File In Section: Product Recalls
Bulletin No.: 10243
Date: August 2010

PRODUCT SAFETY RECALL

SUBJECT: Second Row Safety Belt Interference When Seat Back Returned to Upright Position

MODELS: 2009-2010 Buick Enclave
2009-2010 Chevrolet Traverse
2009-2010 GMC Acadia
2009-2010 Saturn OUTLOOK

2513825

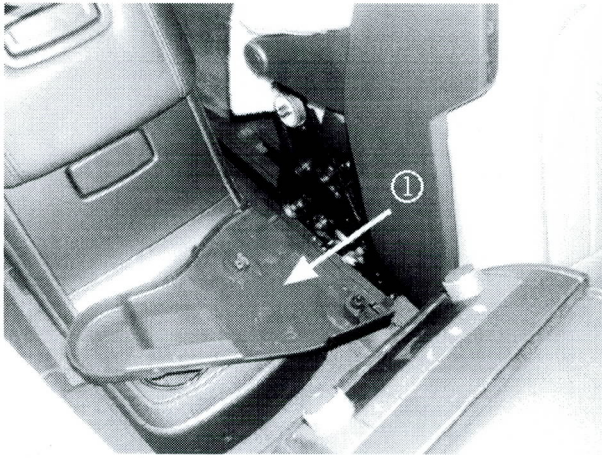
2. Verify proper functioning of the belt buckles and visually inspect each buckle/release button for damage. Refer to the illustration for an example of a damaged buckle.
 - If evidence of buckle damage such as a bent or cracked plastic housing is found, or if stressed witness marks are visible on the housing, replace the seat belt buckle. Refer to *Rear Seat Belt Buckle Replacement* in SI, and then continue on and complete the trim cover rework procedure below.
 - If no buckle damage is found, complete the trim cover rework below on the seat(s)

2509077

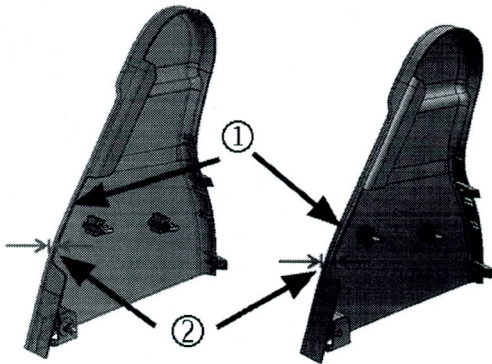
3. Remove the rear seat recliner inner trim cover (1). Refer to *Rear Seat Recliner Outer Finish Cover Replacement - Inboard* in SI.

2509075

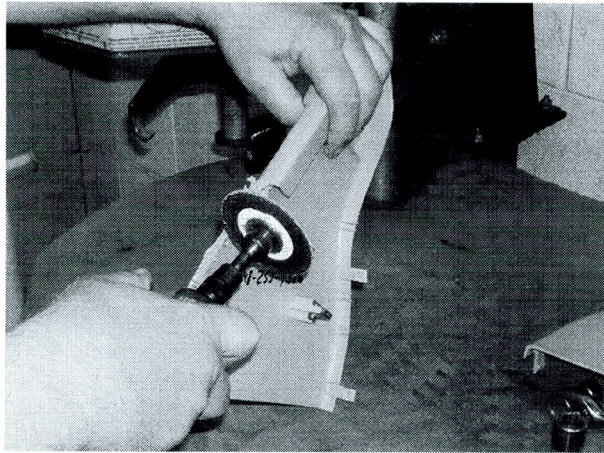
Note: The material to be removed is the standing ledge (1) in the notched-out opening, shown in the examples above. Depending on the design and seat configuration, approximately 3–5 mm (0.120–.200 in) of material (2) will need to be removed.

2509078

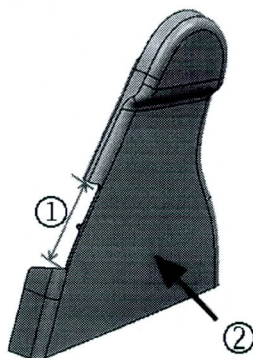
4. Using a DREMEL®, cut-off wheel, or similar tool, grind off/remove the cover's standing ledge material in the notched-out opening.

Note: Maintain the original notch out width (1) of approximately 82 mm (3.230 in) and remove the material until the surface edge is even with the vertical wall surface (2).
